ENCLOSURE 1

LICENSING SUBMITTAL CHANGE PAGES

This enclosure contains change pages for the VCSNS licensing submittal of May 20, 1988 which modify the text and Technical Specifications markups to be appropriate for a design Tave of 587.4⁰F and a thermal design flow of 283500 gpm. All changes are highlighted by dual lines in the right margin. The following pages of the May 20th licensing submittal are affected.

FIGURE 3 2-2 RCS TOTAL FLOW RATE VS. R THREE LOOP OPERATION

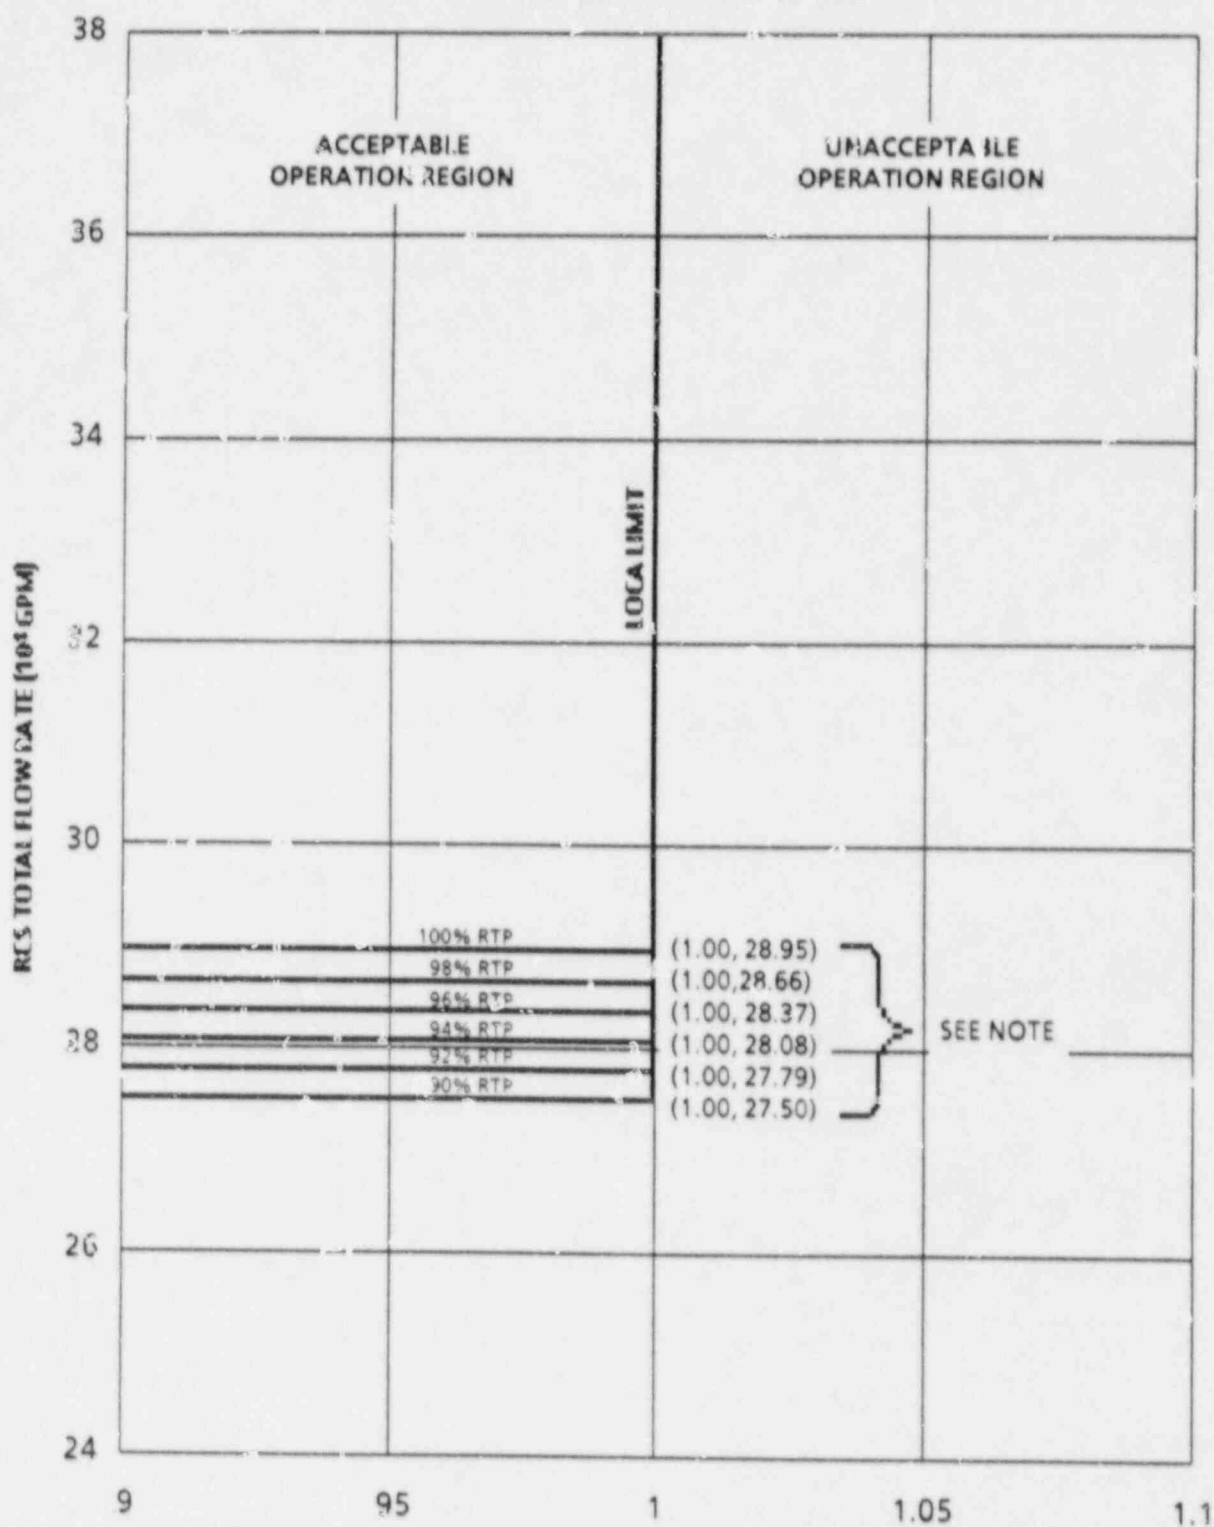
MEASUREMENT UNCERTAINTIES OF 2.1% FOR FLOW
AND 4.0% FOR INCORE MEASUREMENT OF $FN_{\Delta H}$ ARE
INCLUDED IN THIS FIGURE

$$R = FN_{\Delta H} / 1.56 [1.0 + 0.3(1.0 - P)]$$

NOTE: When operating in this region, the restricted power levels shall be considered to be 100% of rated thermal power (RTP) for Figure 2.1-1.
